Reference: Puleo International, LLC - Block 18 Lot 5  
Preliminary/Final Major Site Plan/Use Variance – Technical Review #1  
Town of Clinton, Hunterdon County, New Jersey

Ref: Puleo International, LLC - Block 18 Lot 5  
Preliminary and Final Major Site– Technical Review #1  
Town of Clinton, Hunterdon County, New Jersey

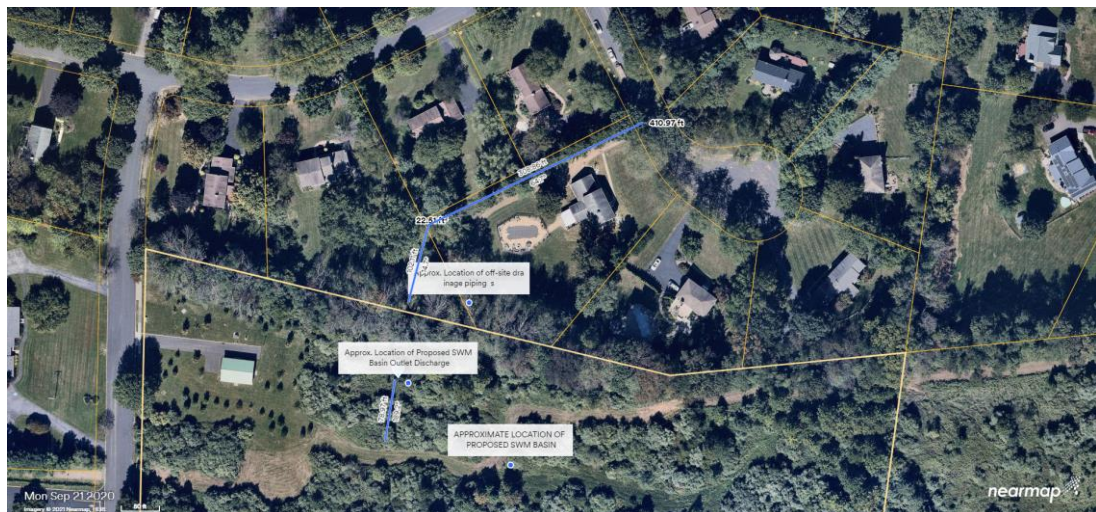
- a) The underdrain shown (sheet 20) in the detail of the Outlet Control Structure (OCS) is not a component of an Infiltration Basin and must be removed.
- b) A full detailed cross section of the SWM Basin must be provided to show the details of the earthen berm construction including impervious core, the basin section with

noted stored water elevations and soil conditions below the bottom of the basin including depth to underlying bedrock and ground water.

- c) A full detail and profile of the outline pipe showing method of installation through the earthen berm with anti-seep collars and a specific detail of the outlet headwall
- d) A full profile and cross sections of the existing outfall ditch from the outfall headwall to the existing inlet headwall on the adjoining property
- e) Sheet 6 of the site plans shows a proposed A-inlet #1-#3 and the utilities profile view shows proposed B-inlets #1-#3, the correct type of inlet proposed should be noted.
